Project	CMHA Meadows RAD Renovations	Addendum Number	2
Project Number	18076.04	Date	09/12/2025
To	All Bidders		
<i>This addendum contains changes to the requirements of the bidding Documents, Project Manual and Construction Drawings which have been issued to date. Such changes are to be incorporated into the Construction Documents and shall apply to the work in the same meaning and force as if they had been included in the original documents. Wherever this Addendum modifies a portion of a paragraph of the Project Manual or a portion of any Drawing, the remainder of the paragraph or Drawing shall remain in force.</i>			
General	Clarifications: <i>Bid Form: See attached revised bid form showing line item for permit fee included.</i> <i>Do the gas lines in the laundry room need to be removed? Is the furnace the only gas fed item within the unit?</i> Response: Gas lines are stubbed into the laundry area for future use of a gas appliance. No work is to be done on the gas lines in the laundry room as a part of this renovation. <i>How should the curb be addressed where the sidewalk on the accessible route widens?</i> Response: See Civil drawings updates as a part of this Addendum. <i>Do y

Sheet H202 – ENLARGED UNITS HVAC PLANS

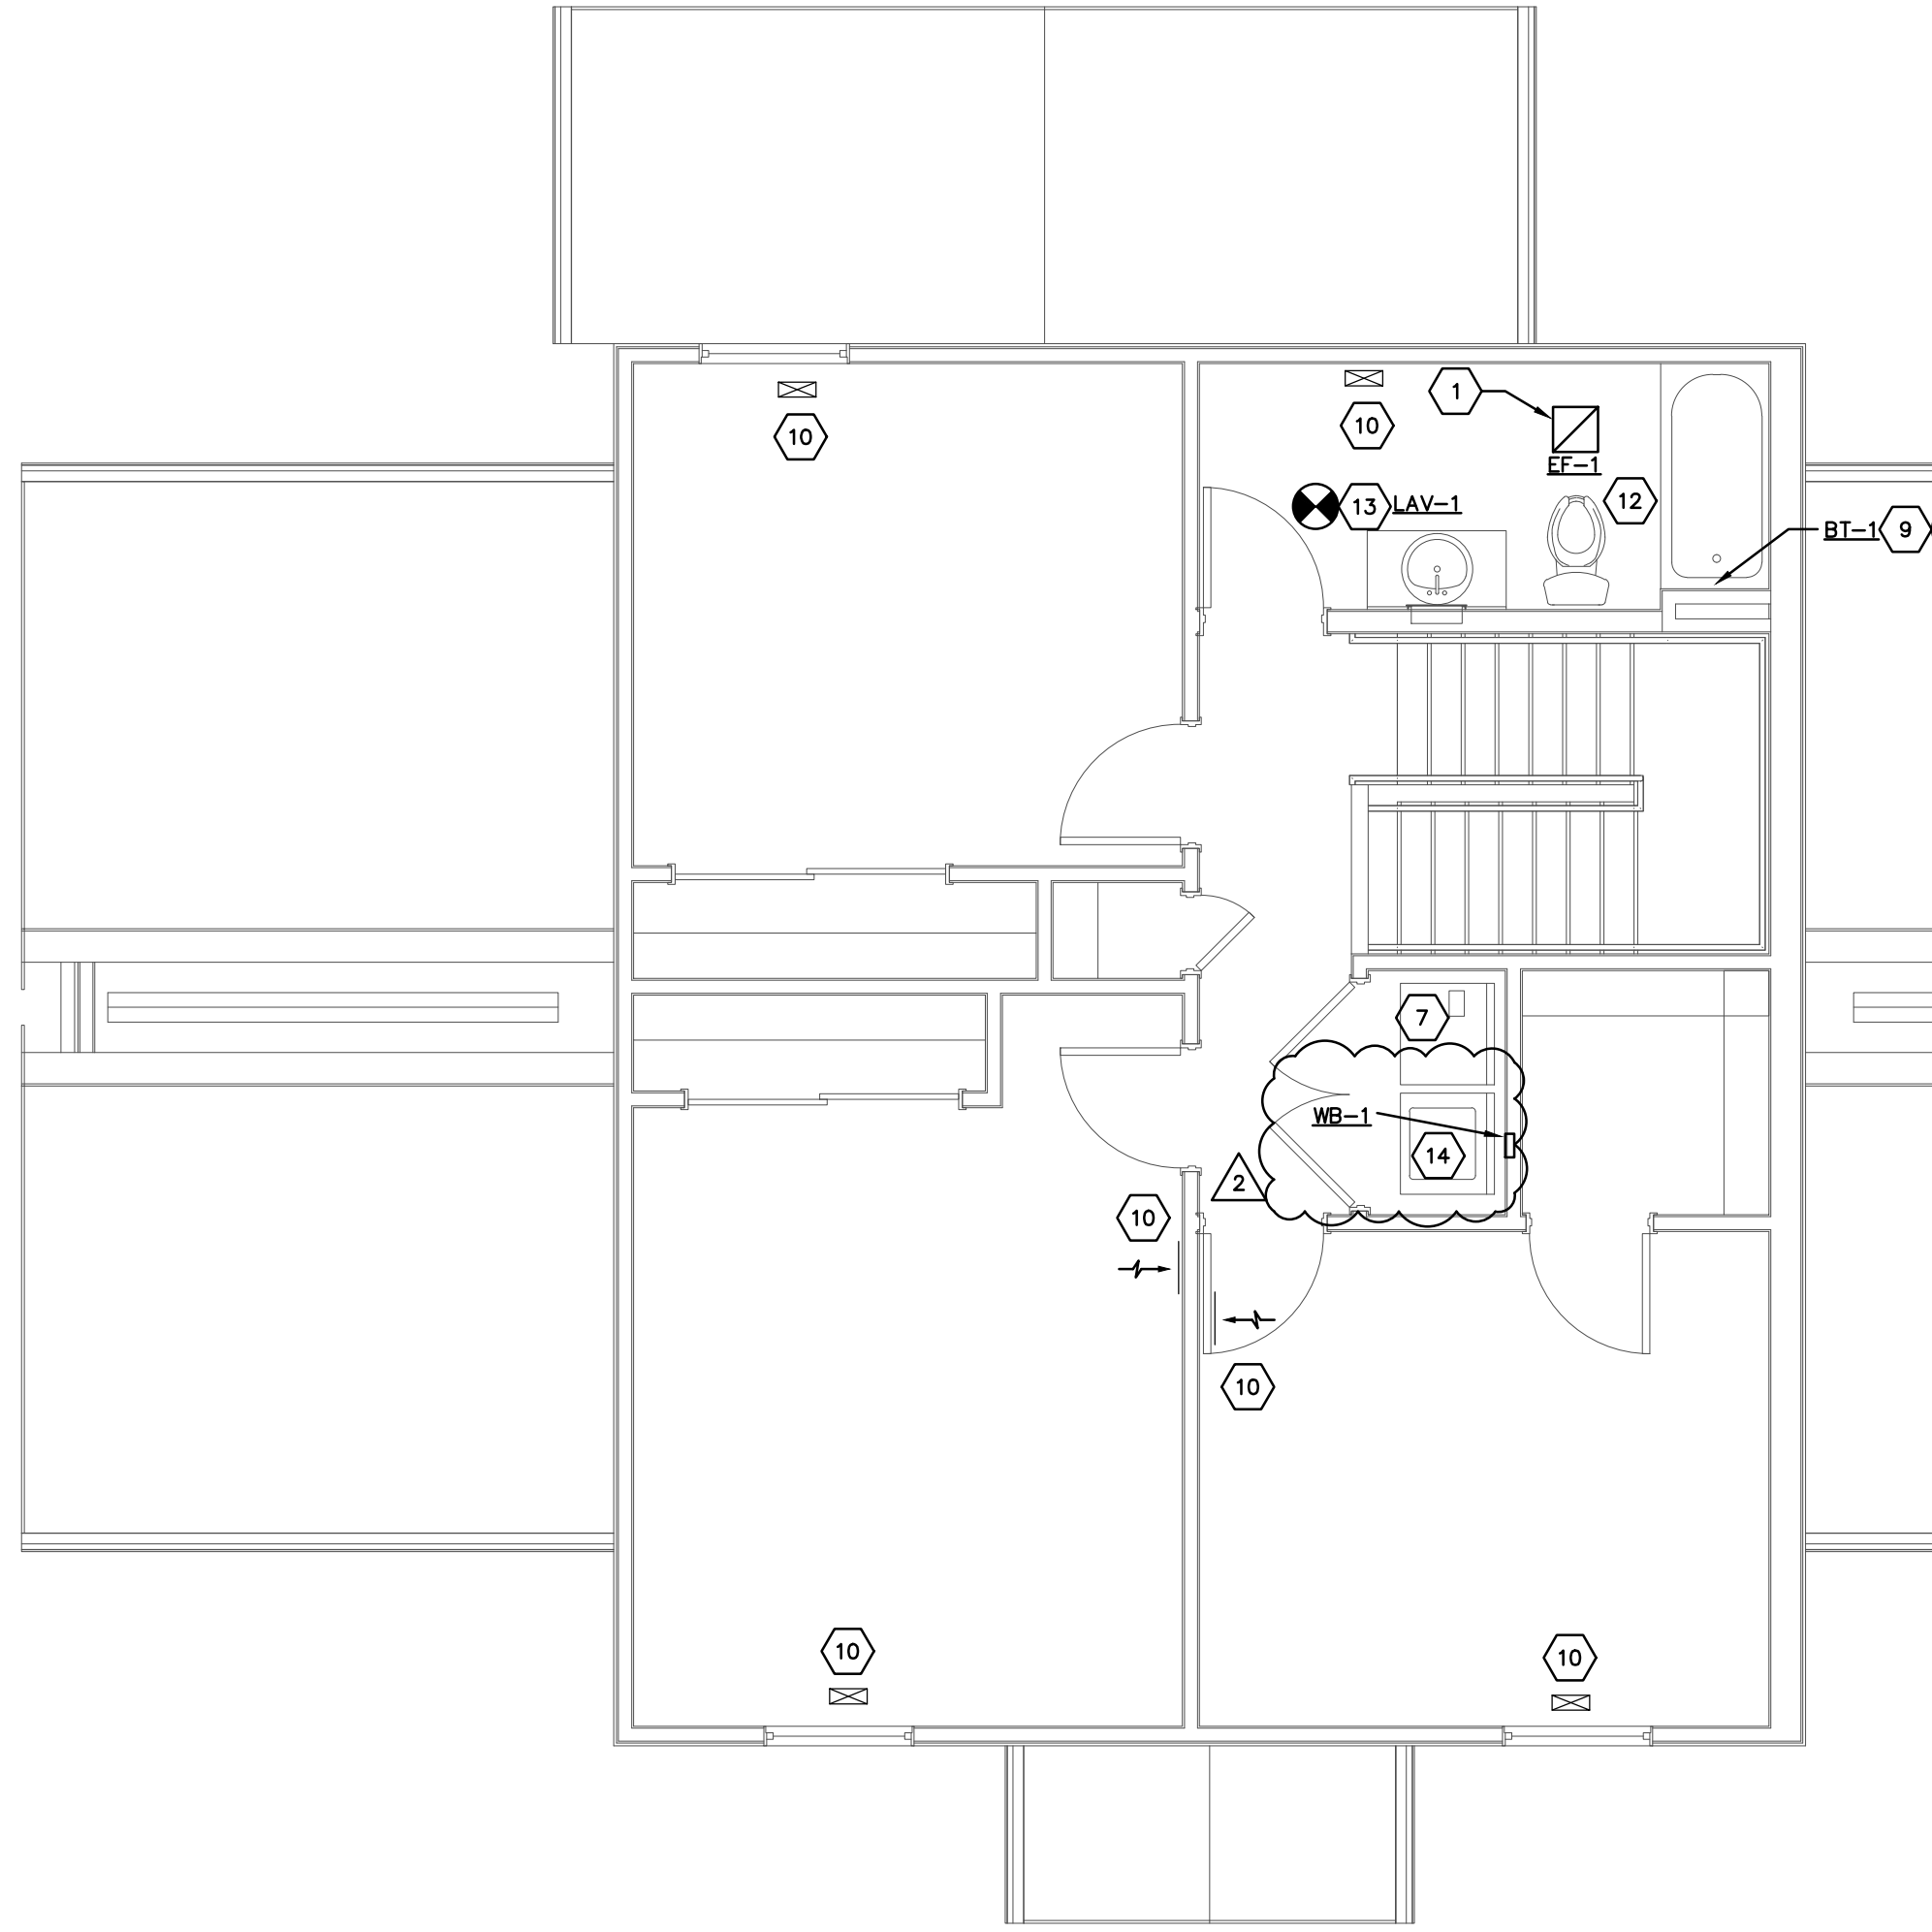
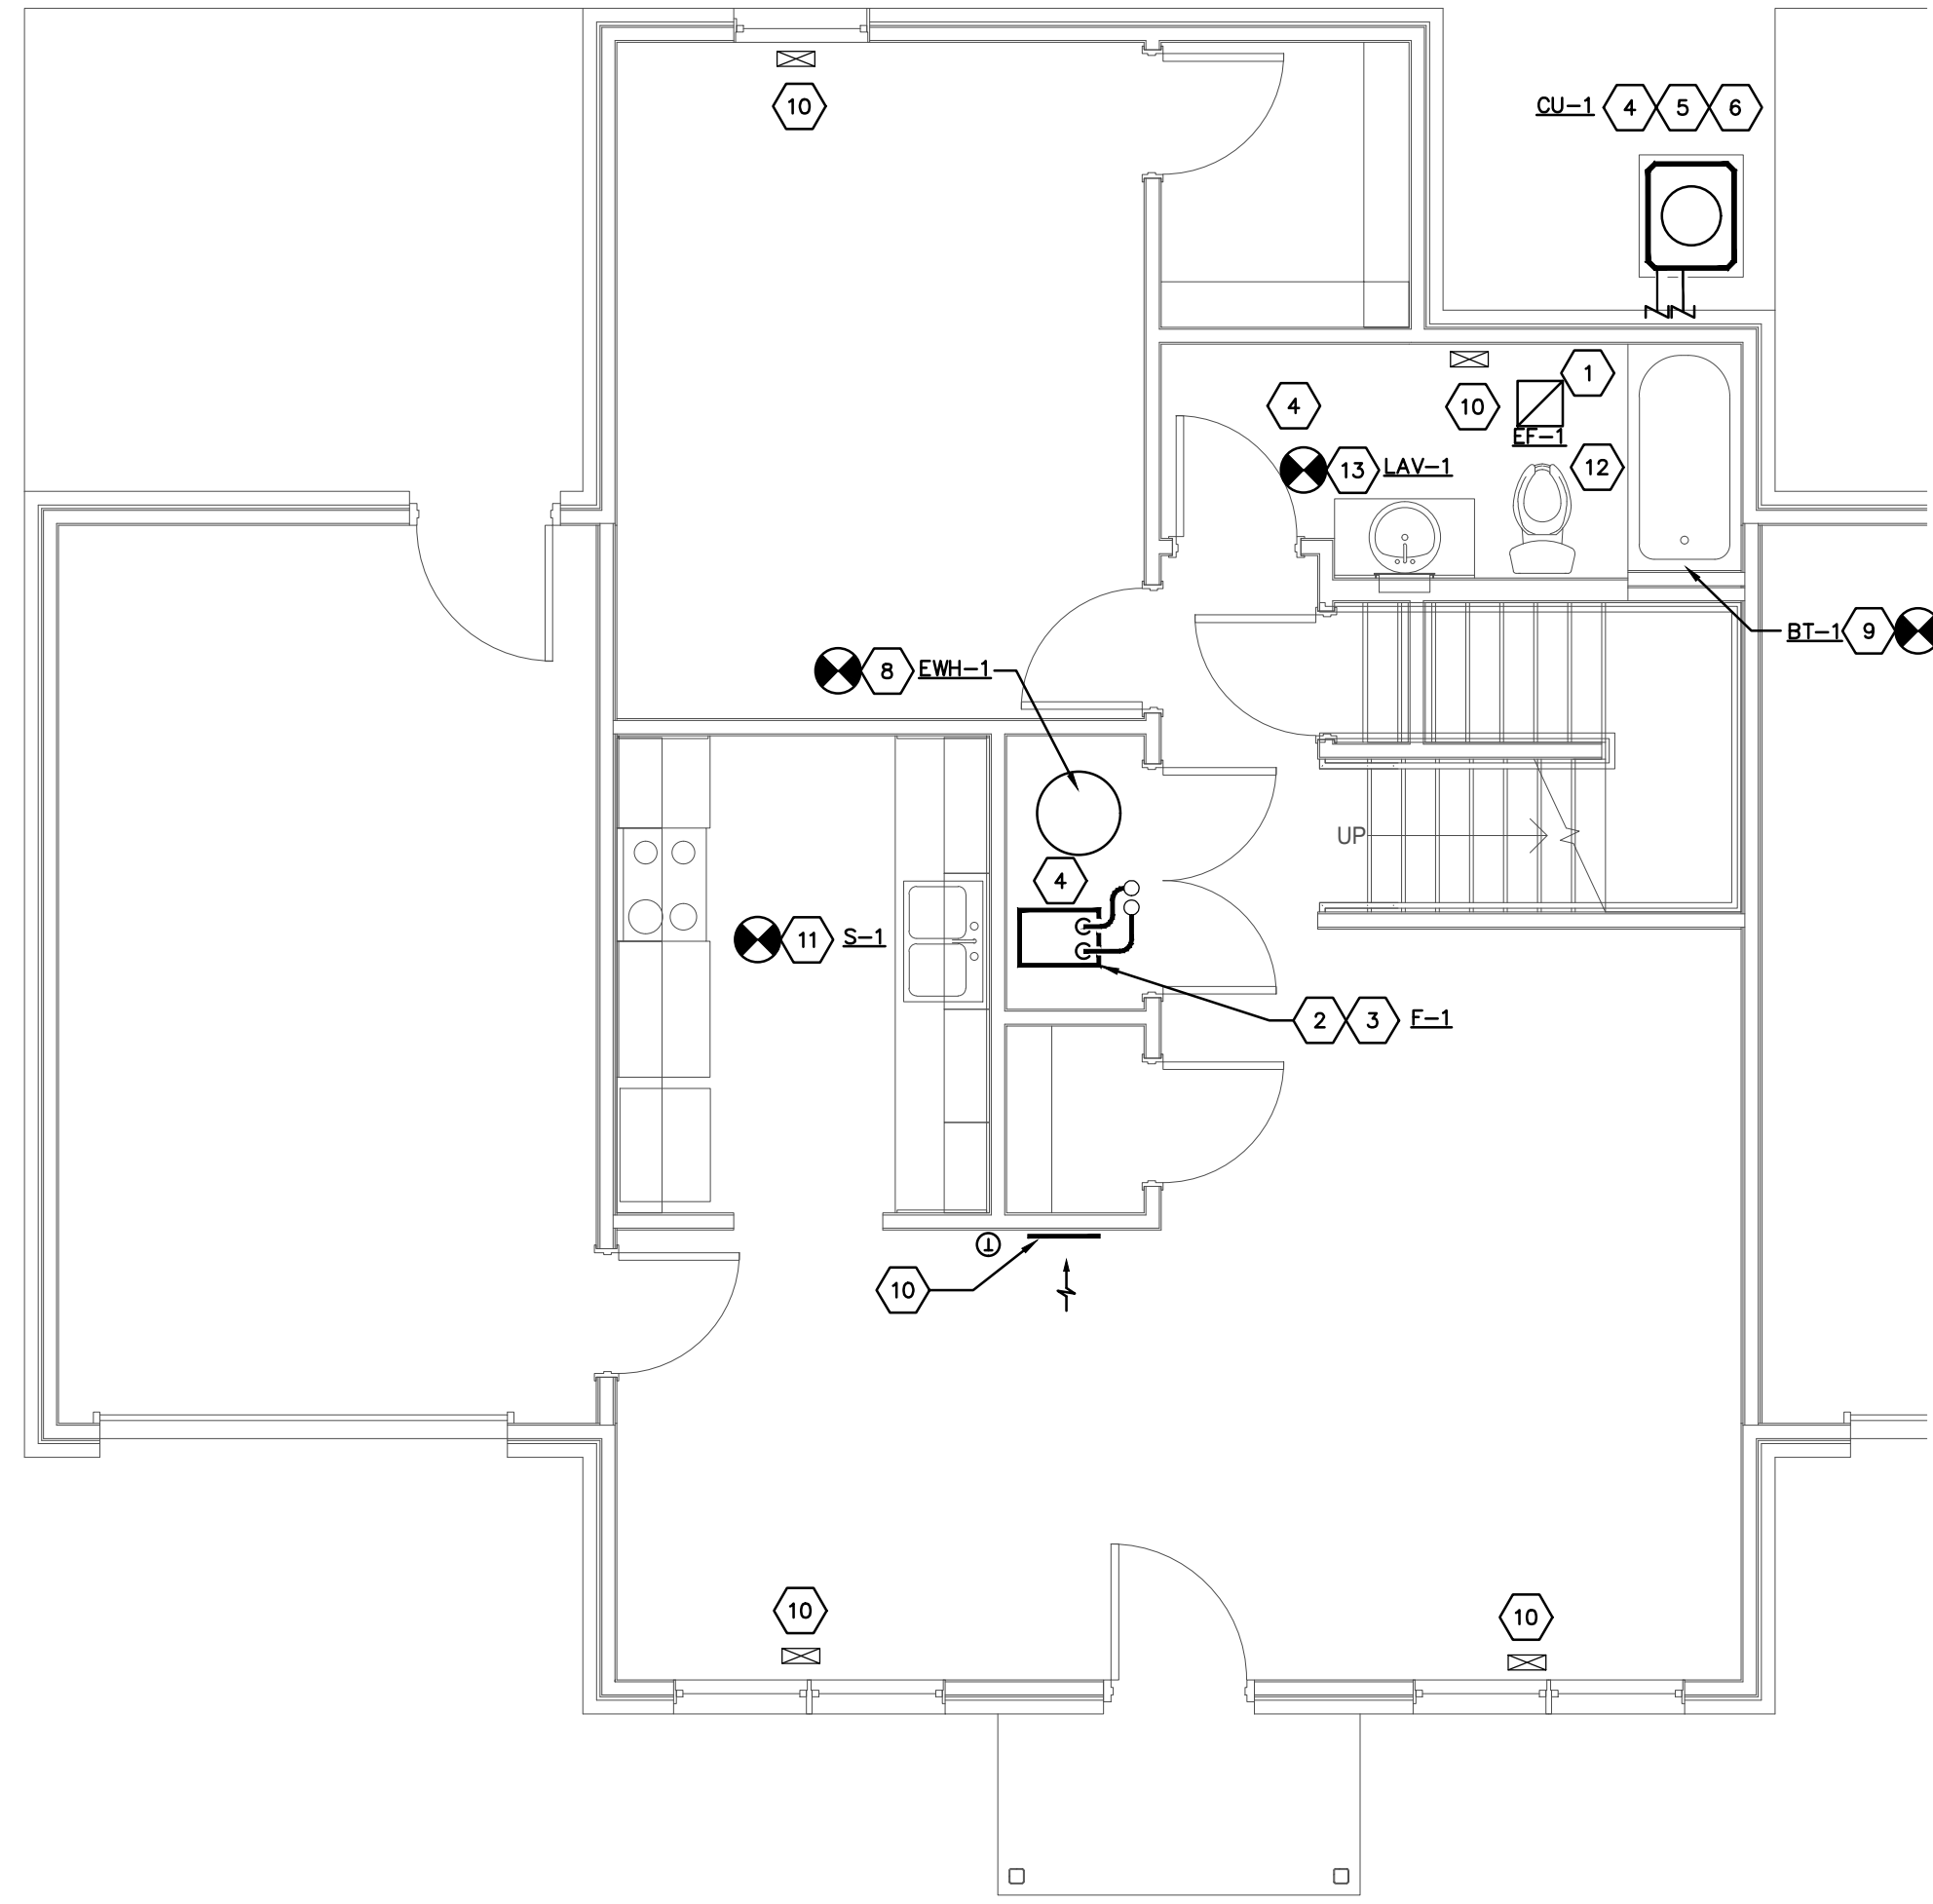
1. ADDED WB-1 washer box replacement in Unit 3-B second floor and Unit 4-A second floor.
2. ADDED Coded Note #14.

- REPLACE EXISTING WASHER BOX AT THIS LOCATION. FIELD VERIFY EXACT LOCATION. SEE "PLUMBING FIXTURE SCHEDULE" ON SHEET H900.
